TAS4

From: Dale, Michael, NMENV
To: Everett, Mark C
Cc: Cobrain, Dave, NMENV; Kulis, Jerzy, NMENV; Ball, Theodore T
Subject: RE: R-54 proposed well design
Attachments:

## **R-54 Well Objectives**

## **R-54 Recommended Well Design**

Figure 2. Proposed well design, R-54 (Qal = alluvium, Qbt 1g = lower vitric Tshirege Member of Bandelier Tuff, Qct – Cero Toledo interval, Qbo = Otowi Member of Bandelier Tuff, Qbog = Guaje Pumice Bed, Tb4 = Cerros del Rio volcanic series, Tpf = Puye Formation).

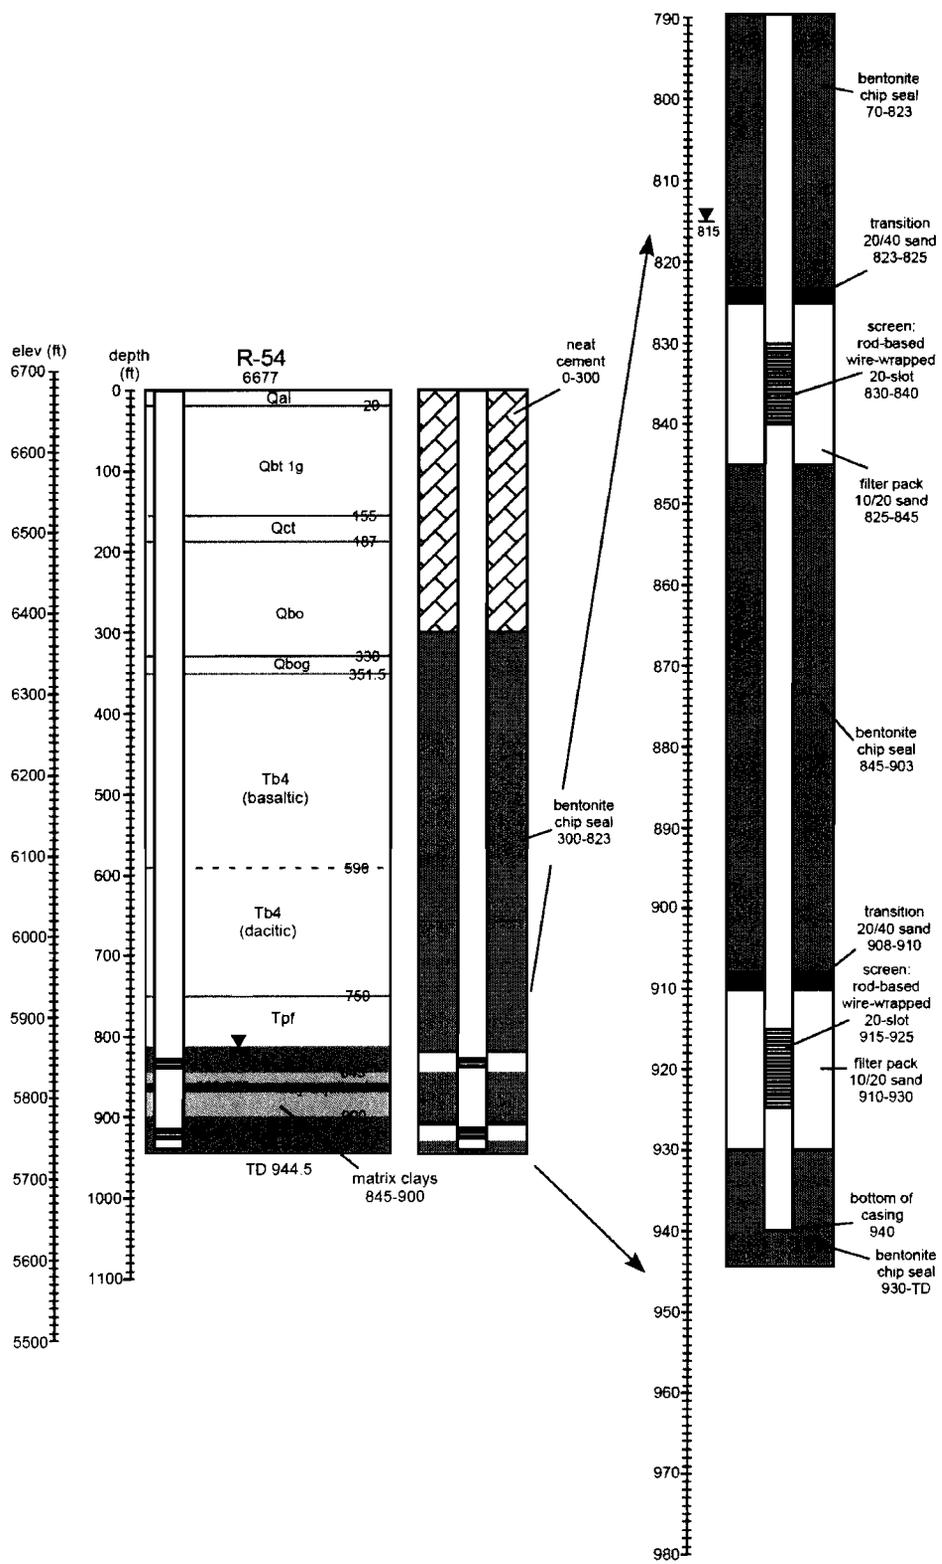
This e-mail serves as NMED approval for installation of regional aquifer well R-54 as proposed in the document attached to the original e-mail received by NMED today (January 7, 2010 at 1:47 PM). This approval is based on the information available to NMED at the time of the approval. NMED understands that LANL will provide the results of preliminary sampling, any modifications to the well design proposed in the above-mentioned e-mail, and any additional information related to the installation of well R-54 as soon as such information becomes available. In addition, LANL shall notify HWB within three days of water-quality sampling at the conclusion of the aquifer-testing period at R-54 screens 1 and 2. If the referenced Baski sampling system is not installed within one month of placing the packer between screens 1 and 2, LANL shall collect representative samples from screen 1 via temporary or removable pump. LANL shall give notice of this installation to the New Mexico Office of the State Engineer as soon as possible. Thank you.
